# **Environmental Impact Assessment Report Don Sahong Hydropower Project, Lao PDR**

# **Review Report - Draft**

Figure 2-2: Main temporary and permanent elements of the proposed DSHEP.

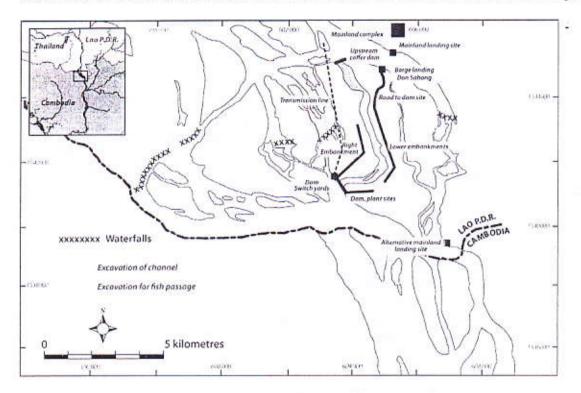
- 14 Rock excavation works in the Hou Sahong will be undertaken to lessen head losses in the channel leading to the powerhouse. The excavations will take place on a 2 km upstream stretch to a depth up to 5 m. Lesser excavations will be made on the downstream side of the powerhouse. Some of the excavation masses will be used to construct embankments and roads, but about 1.3 million m³ of surplus rock and 0.7 million m³ of other spoil has to be disposed of. No areas have been reserved for these masses, but it is mentioned that they will be disposed of in low-lying areas, possibly within the embankment area. As for now no borrow and spoils disposal plans exist.

- The installed capacity of DSHEP is some 300 MW<sup>1</sup>. No figures on the maximum discharge are given in the EIA Report, but from Fig. 2.6 in the report it can be re-calculated that the maximum discharge will be about 2,000 m<sup>3</sup>/s and the turbine rated head some 20 m. The flow will be controlled in such a way that at least an agreed minimum flow<sup>2</sup> (yet to be determined) over the Khone Phapeng falls is always maintained. The control will be based on the observed water level upstream at Thako using a water level gauge installed for this purpose. There are no provisions on how to maintain flows in the adjacent channels and at other water falls (notably the Li Phi Falls).

- Some channels are proposed to be modified to provide upstream migration routes for fish when the only current year-round fish passage at Hou Sahong is blocked, but no structures appear to have been planned to control the distribution of flow between Khone Phapeng, the DSHEP and the other channels after modification. It is to be noted that the

Figure 4-1: Seasonal distribution of Mekong flows upstream (Pakse) and downstream (Stung Treng) of the DSHEP site.

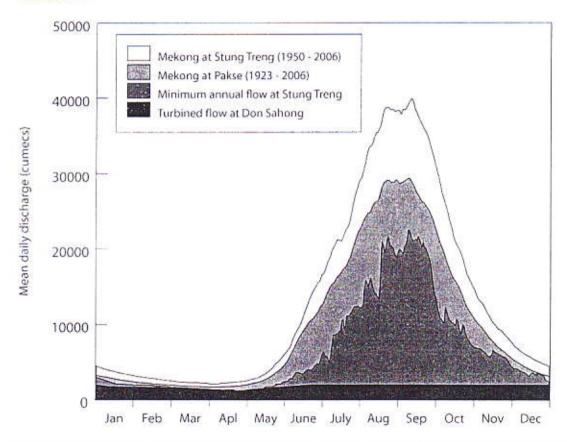
- 43 The Project Proponent's hydrological considerations are based on adjusted Pakse flows. As the methodology of the adjustments by the Proponent is not set out in the EIA Report, they are here complemented by an analysis using data of Stung Treng downstream the DSHEP. It would however be useful to use both the up- and downstream stations in the adjusted hydrological flow assessment for the site, and verify it with (short-term) observations at site.

- Based on the 1950 to 2006 time series of flow data at the Mekong in Stung Treng about one third of all Mekong flows are estimated to pass through the turbines during the year. If a 1,000 m³/s environmental flow over the falls and other channels is maintained at all times the turbines would operate below their installed capacity of 2,000 m³/s for 92 days in average years, and would operate at less than 50% of installed capacity for a period of 116 days in dry years. A lower environmental flow of 800 m³/s would increase turbine throughput and generation. The turbines would then operate below their installed capacity for some 78 days in average years, and would operate at less than 50% of installed capacity for a period of 86 days in dry years.

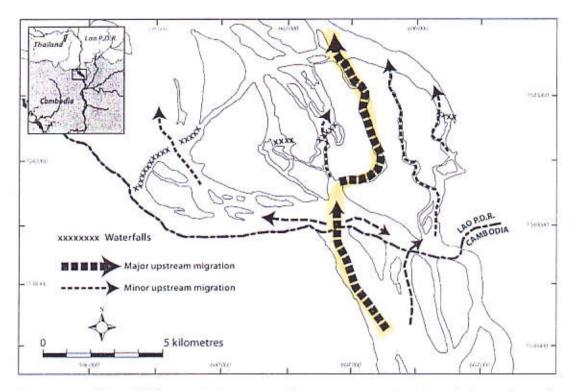
The EIA Report notes that effective mitigation of the impacts of the dam on fish migration is central to the DSHEP<sup>31</sup>. The proposed mitigation is to physically alter the channels adjacent to the Hou Sahong, namely the Hou Sadam and the Hou Xang Peuk, so that fish can traverse them throughout the year. In addition, there would be controls on fishing effort introduced in the two channels. Conceptually, the mitigation is a good idea. However, there are two difficulties with the proposed mitigation. Firstly, as correctly pointed out in appendix G channel modifications (which, it appears, have not previously been undertaken on

- The channel modification proposed in the EIA Report only relates to upstream movement of fish. The EIA Report has yet to recognise the importance of downstream movement of fish. There are two issues of concern: firstly, mortality of fish (all life stages) passing through the turbines; and secondly, the proportion of the Mekong's flow which is directed through the turbines.

Figure 8-1: Alternative hydropower projects at the Khone Falls fault line. The EIA Report mentions two alternatives, Khone Phapeng and Hou Xang Peuk. The third alternative, the Tad Samphamit project is of similar concept than the Khone Phapeng.

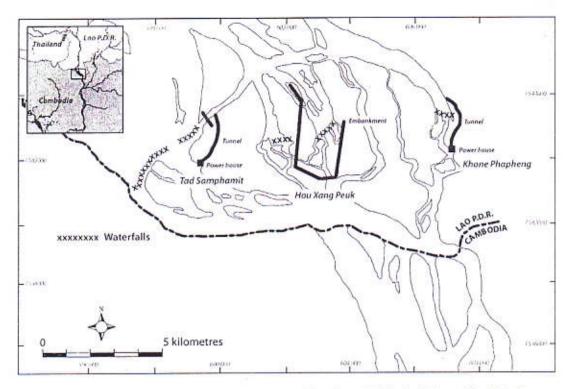
- 81 The DSHEP FS is reported to consider several different options based on different diversion amounts and installed capacity ranging from 180 to 480 MW. However, the effects of these options are not discussed in the EIA Report, except the effect of different environmental flows at Khone Phapeng on flow diverted to the power station. Two other schemes not located in the Hou Sahong, but in alternate channels of the Khone Falls area are briefly discussed.

- The FIA Report mentions that this alternative has also been studied by Maunsell/Lahmeyer in a 2004 desk study. The assessment presented in the EIA Report is apparently based on this previous study. The project studied by Maunsell/Lahmeyer was significantly smaller than the DSHEP, only 60 MW, but would have lesser impacts on upstream fish migration as the water would pass the falls in a tunnel and leave all fish passages unaffected.

- 83 The second alternative discussed the Hou Xang Peuk alternative. The EIA Report mentions that this alternative remains unexplored, but estimates that it would be comparable in size with the DSHEP, but at a much higher cost. It would also have comparable ecological impacts, as it would restrict wet season fish migration which is currently possible. There is currently no dry season migration in this channel.
